Honeywell 165 EILEEN WAY SYOSSET, NEW YORK 11791	
PCB (REF) K14644V1	REV.A
TITLE	
DRAWING NUMBER	PRESA5817CB
COMPUTER FILE NAME	PRESA5817CB.SCH
DATE: 3/06/07	SHEET 1 OF 1

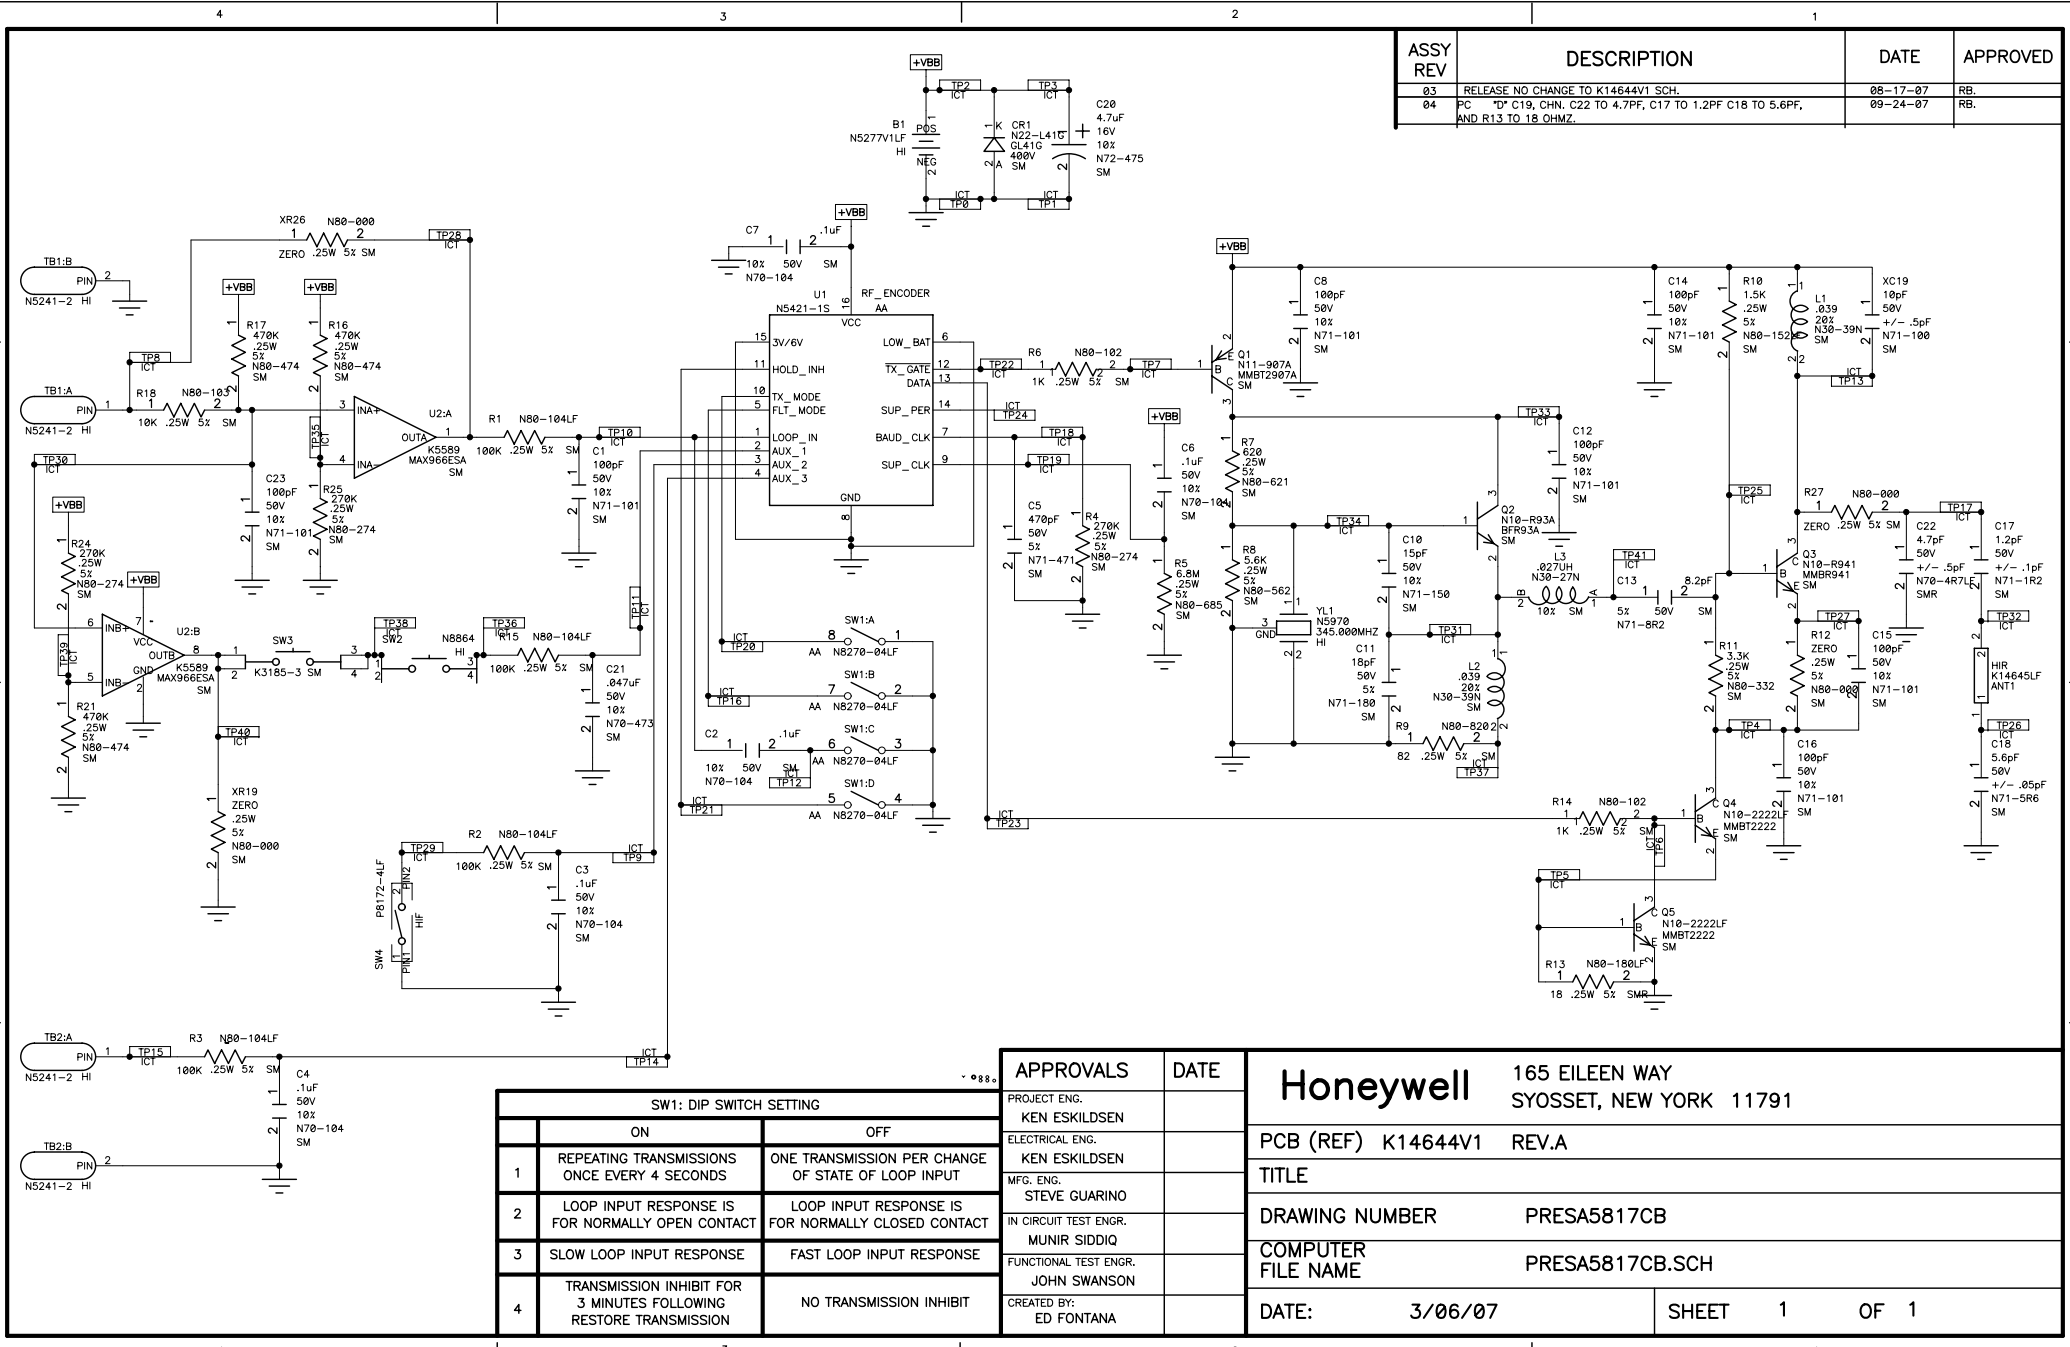
ASSY REV	DESCRIPTION	DATE	APPROVED
03	RELEASE NO CHANGE TO K14644V1 SCH.	08-17-07	RB.
04	PC "D" C19, CHN. C22 TO 4.7PF, C17 TO 1.2PF C18 TO 5.6PF, AND R13 TO 18 OHMZ.	09-24-07	RB.
